EC18-004a

2018 QX60; MIL ON WITH DTC P34A5 AND/OR P34A9 STORED

2018 QX60 (L50)

Electric Intake Valve Timing Control Module Location

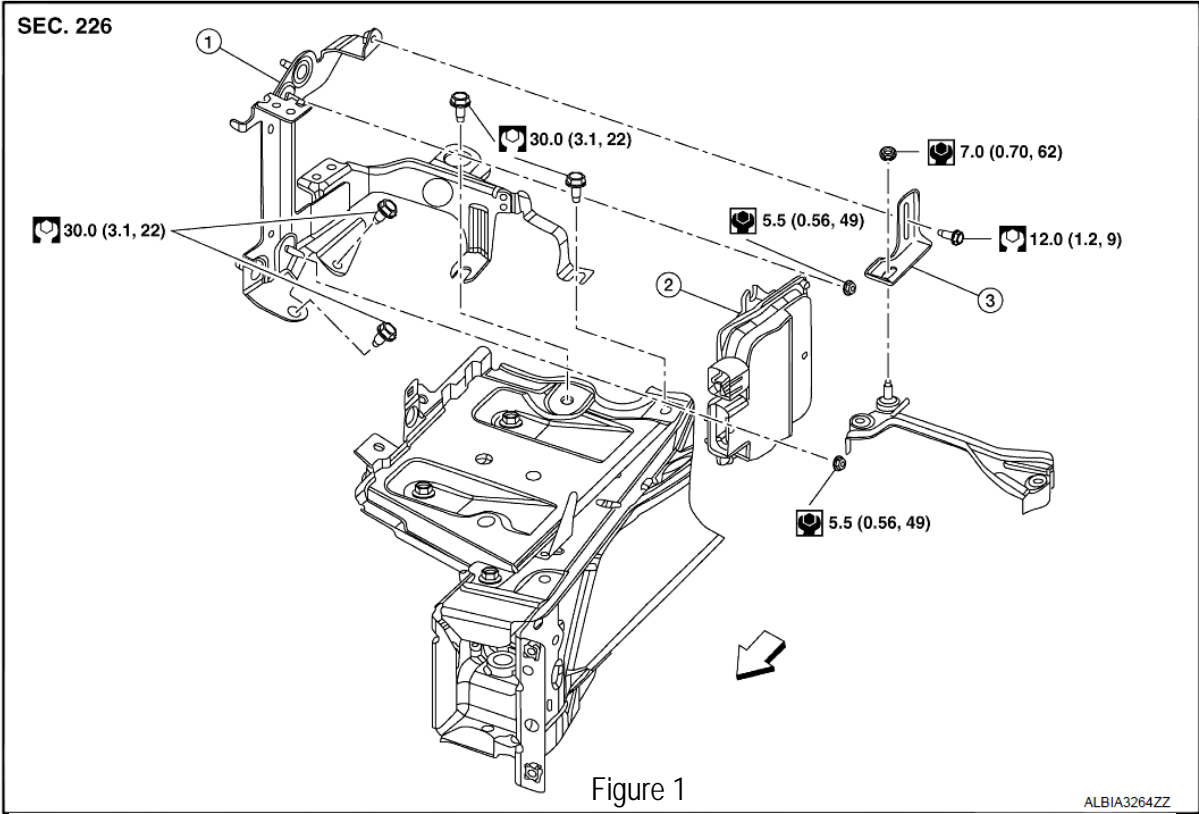
Replace the electric intake valve timing control module (see Figure 1 on Page 2).

- Electric intake valve timing control module is listed in the Parts Information of this bulletin.
- Refer to the Electronic Service Manual (ESM), section **ENGINE > ENGINE CONTROL SYSTEM**, for replacement information.
- Make sure to perform Electric IVT Control Actuator Position Learning after replacement of the module.

Figure 2

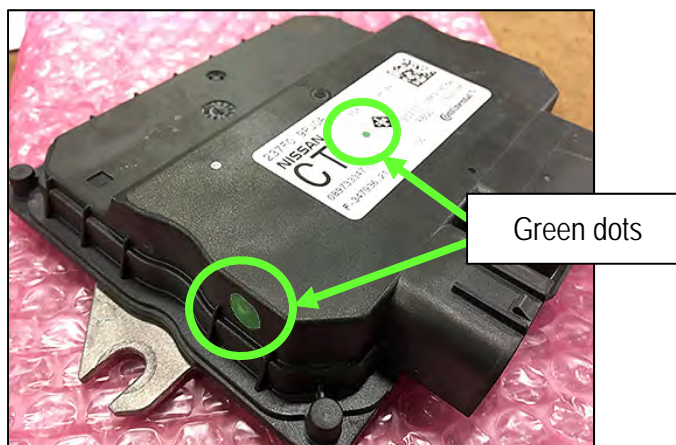
- (1) The new part must have either the green dots as shown in Figure 2 or an "AB" with additional QR on the label as shown in Figure 3, to indicate that it has the correct software version.
